STAFF RECOMMENDATION

E. Keller
NCPC File No. 6383

GEORGETOWN WATERFRONT PARK
WISCONSIN AVENUE TERMINUS,
Wisconsin Avenue to 31st Street, NW,
Washington, DC

June 30, 2005

ENLARGEMENT SHOWING PERGOLA LOCATION IN PARK

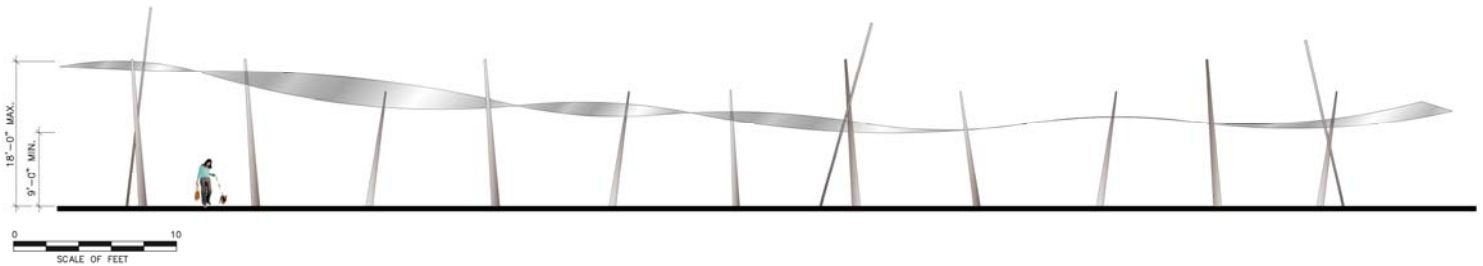
However, the staff is disappointed in the provided documentation concerning the evolving design of the pergola structure and its seating areas. No material details or defining design details have

been submitted by the Park Service regarding specifics of height of the various vertical supports or their material composition. Furthermore, no information was provided regarding the seating materials of the pergola area or the nature of the canopy material. No specifics are noted giving any written description of the lighting scheme contemplated beneath the structure. Given the lack of detail, staff was unable to evaluate in a preliminary fashion the relevance of the pergola's design progression toward its integration with the concept of an open, light, and contemporized shade element. With the omission of any details about the structure, staff recommends deferral of its preliminary design approval.

- The proposed design of the pergola structure and its attendant seating, which is deferred until more detailed information is provided by the National Park Service on the structure's material composition, exact structuring layout, and complete description and detail of the overarching roof material.
- The pedestrian sidewalk north extension at Wisconsin Avenue, which should be either further revised as a receptive and refinedly designed entry point, or eliminated from the park sidewalk design entirely.
- Use of the multiple-lamp Washington Globe at the Wisconsin Avenue park entrance.

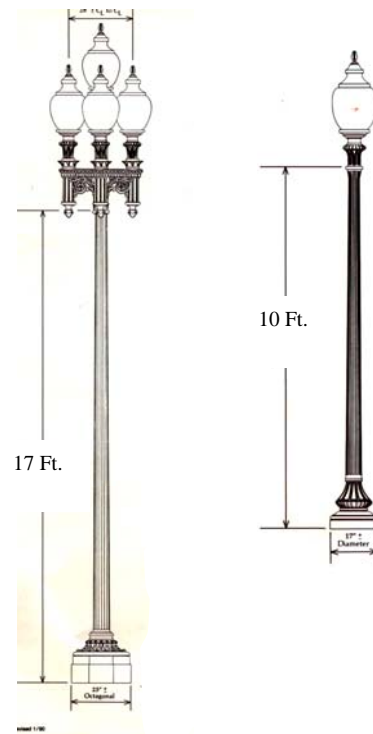
As an additional point, the staff believes the Wisconsin Avenue entry sidewalk at the K Street edge presents itself as a half-attempted effort to represent a sidewalk focal point. A simplified but refined sidewalk pavement layout plan containing the accessible ramps is considered to be more appropriate. A single comprehensive form for the walk pavement is necessary versus the current compound geometric configuration. Short of that; the staff review finds the small sidewalk bump-out should be removed if it can not be modified.

Additionally, staff finds the pedestrian sidewalk area at the Wisconsin Avenue entrance to the park should be further revised as a receptive and refinedly designed entry point or eliminated from the park sidewalk design entirely.

WASHINGTON MULTI-GLOBE AND SINGLE GLOBE STREETLIGHT

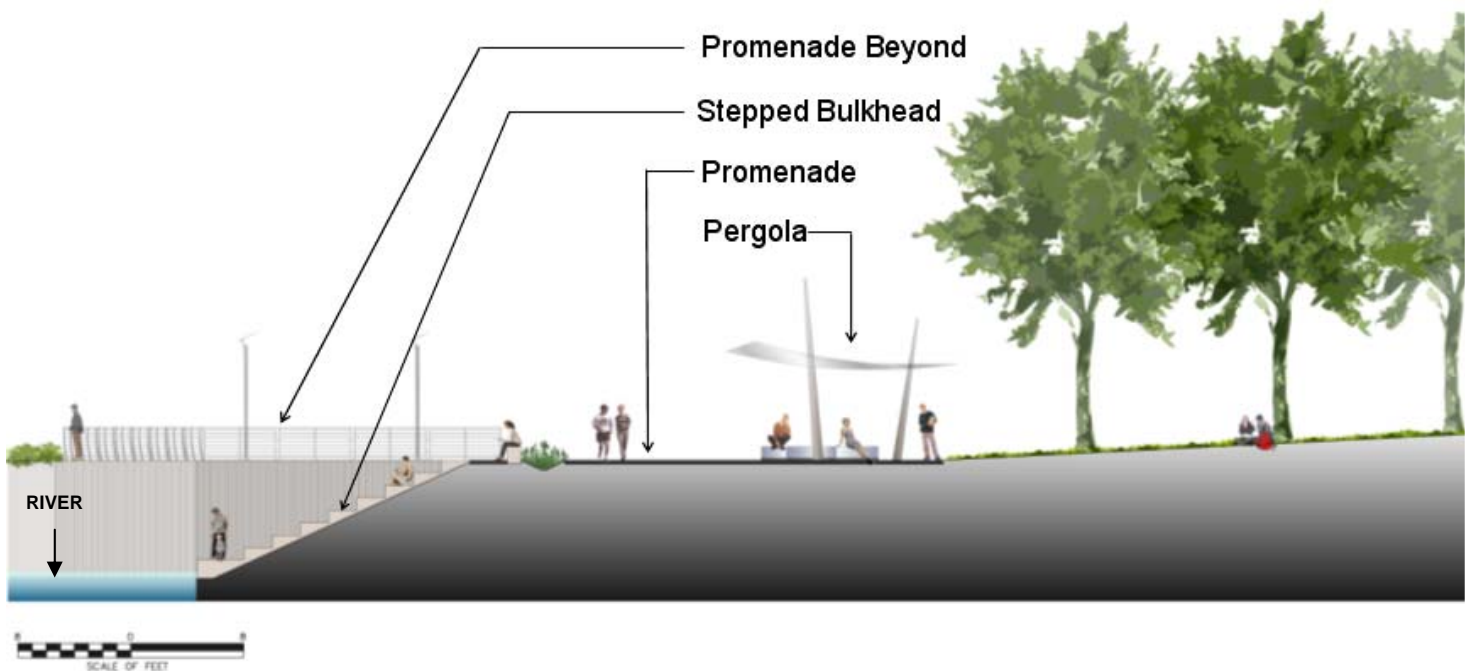
Staff also recommends just a single Washington Globe streetlight should be utilized to adhere to the sympathetic design established within the western section of the approved park, which uses only the single globe fixture along K Street, NW. The more massive and taller multi-globe fixtures, placed at each side of the entry point, compete with the nearby tall piers of the Whitehurst Freeway and would cast additional light toward the freeway structure itself.
